AGENDA
President and Board of Trustees
Village of Arlington Heights
Board Room

Arlington Heights Village Hall
33 S. Arlington Heights Road
Arlington Heights, IL 60005
May 1, 2023
7:30 PM

SITE DEMOLITION PLAN

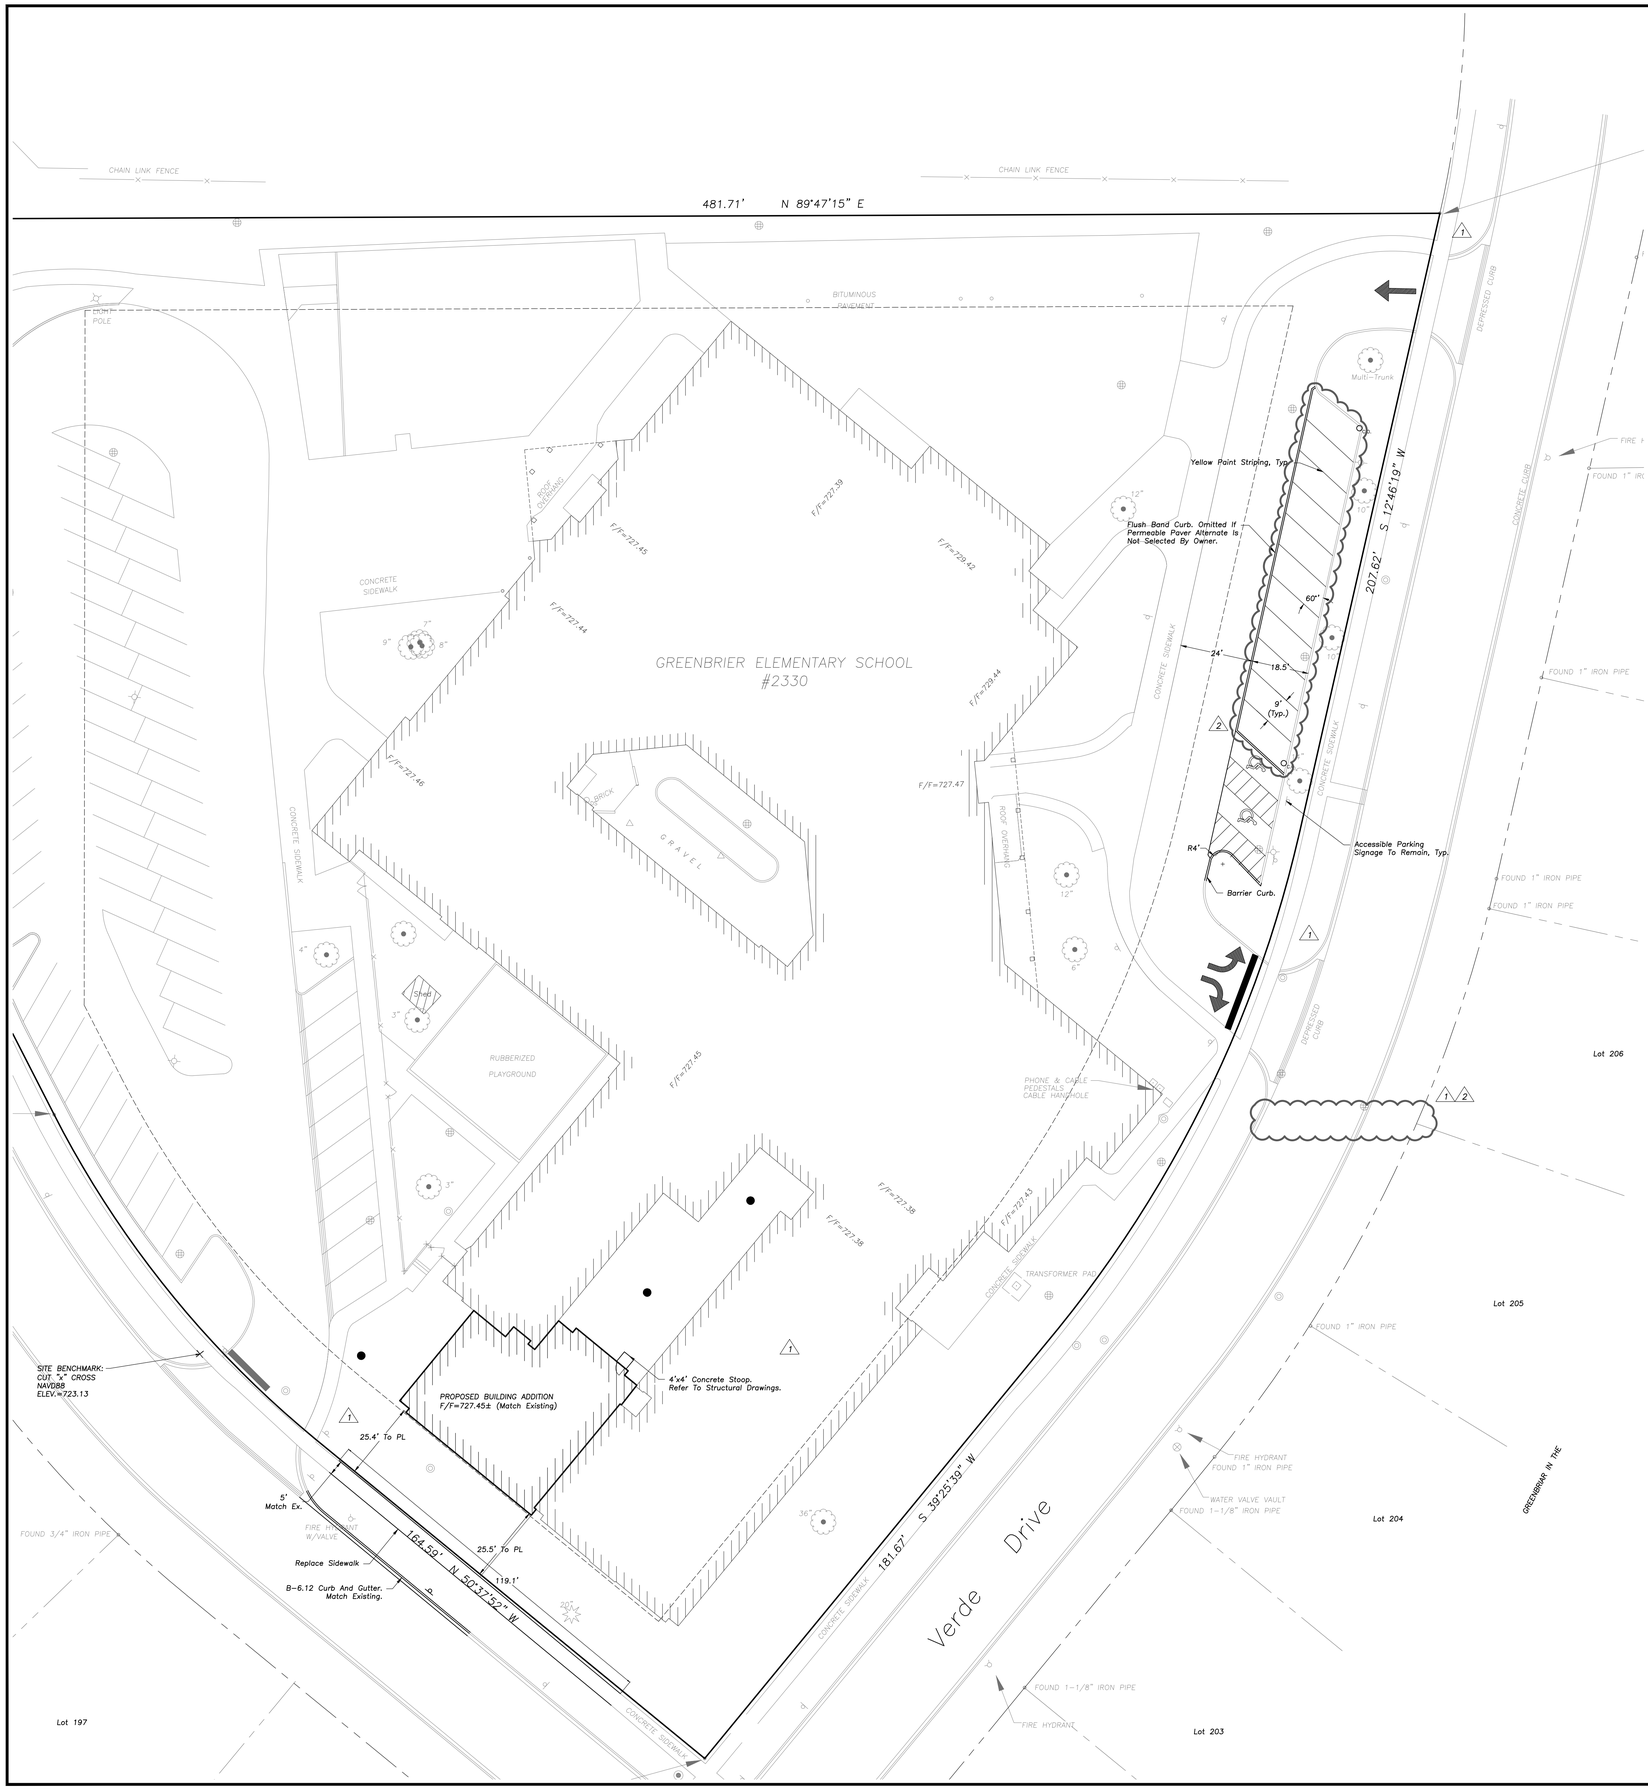
16. On sheet C101 Site Demolition Plan, the utilities to be removed do not correlate with the utilities shown on sheet C001 Topographical Survey. Verify the existing utilities.
